**TOWN OF MOUNTAIN VILLAGE  
REGULAR DESIGN REVIEW BOARD MEETING  
THURSDAY JUNE 7, 2018 10:00 AM  
2nd FLOOR CONFERENCE ROOM, MOUNTAIN VILLAGE TOWN HALL  
455 MOUNTAIN VILLAGE BLVD, MOUNTAIN VILLAGE, COLORADO  
AGENDA**

**TO:** Design Review Board  
**FROM:** Dave Bangert, Senior Planner  
**FOR:** Meeting of June 7, 2018  
**DATE:** May 23, 2018  
**RE:** Initial Architectural and Site Review for a new single-family dwelling on Lot 359, 115 Snowfield Dr.

**TO:** Design Review Board  
**FROM:** Sam Starr, Planner  
**FOR:** Meeting of June 7, 2018  
**DATE:** May 31, 2018  
**RE:** Consideration of an Initial Architectural Site Review application for a new single-family dwelling on Lot 600BR-1

**1 GRADING & DRAINAGE PLAN**  
 SCALE: 1/8" = 1'-0"

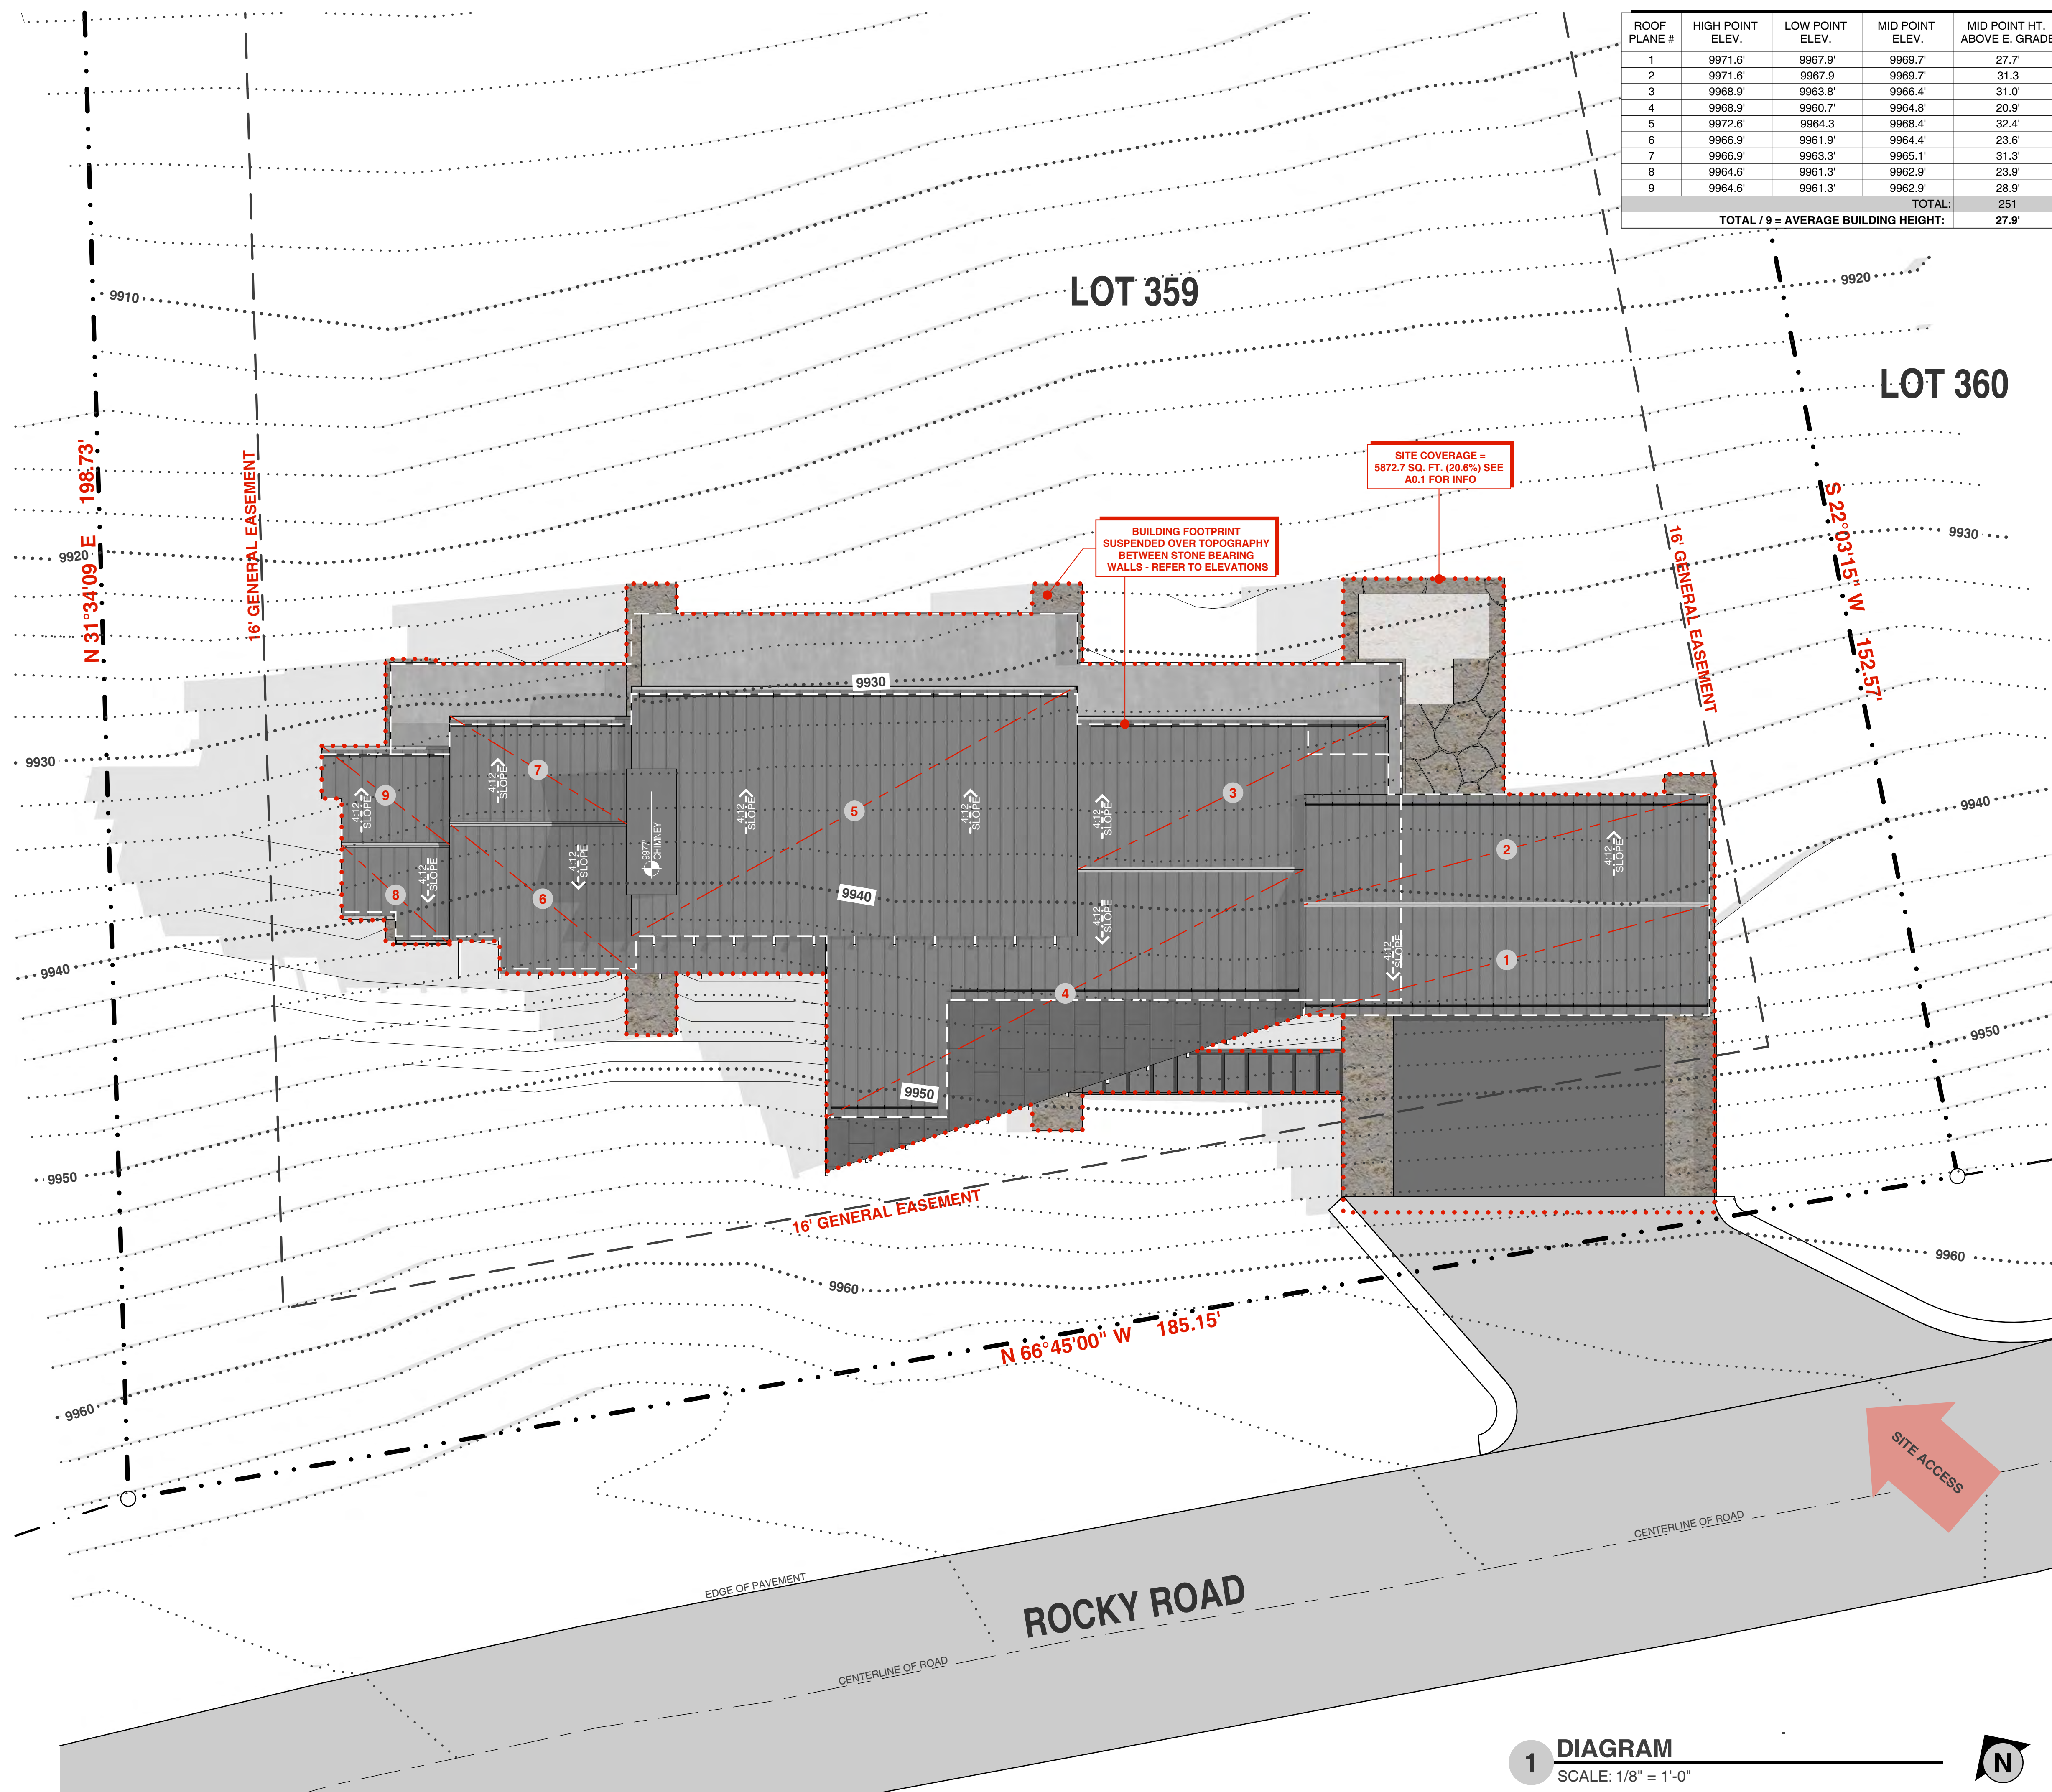
The applicant has provided a grading and drainage plan prepared by Uncompahgre Engineering, LLC for the proposed development. Positive drainage away from the structures has been provided with all disturbed areas and to have final grades of 2:1 which will match existing grades on the property.

sheet  
**A1.5**

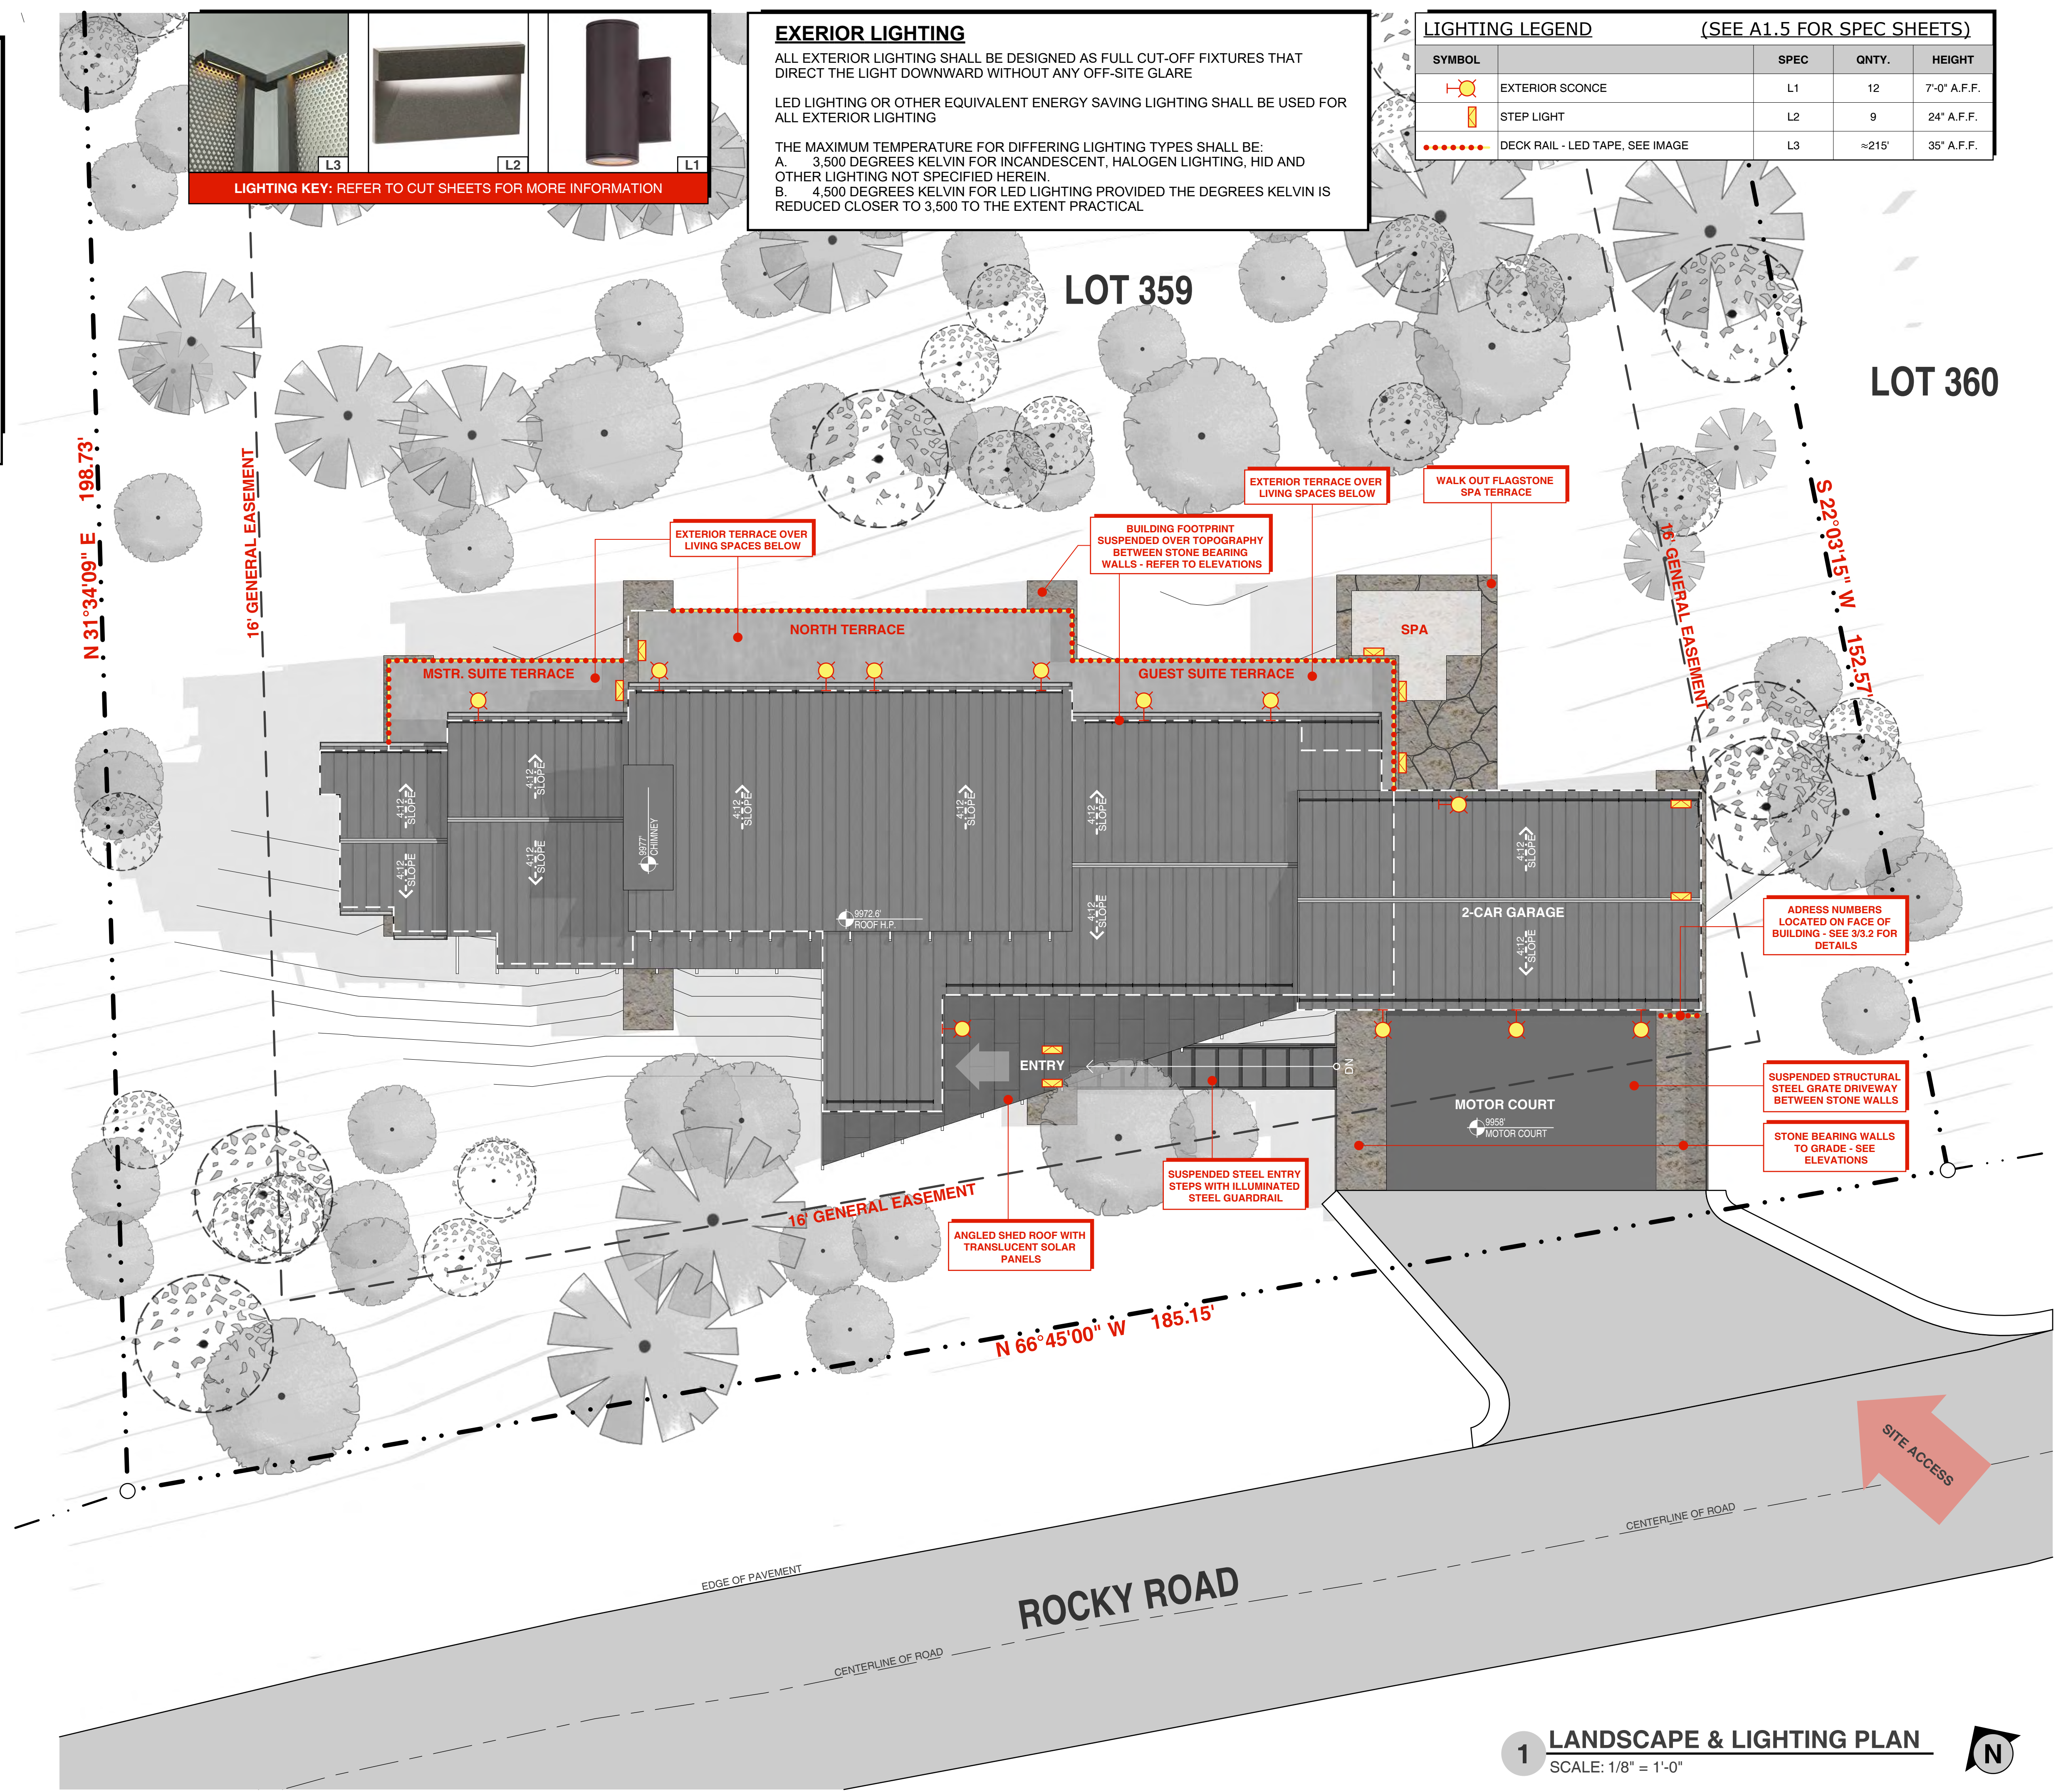
The exterior lighting plan shows 12 sconces and 9 step lights and 215 linear feet of LED strip lighting concealed in the deck handrails. Locations include terraces, egresses and a front entrance patio. The DRB should determine if this amount of exterior lighting is appropriate for the design and the site.
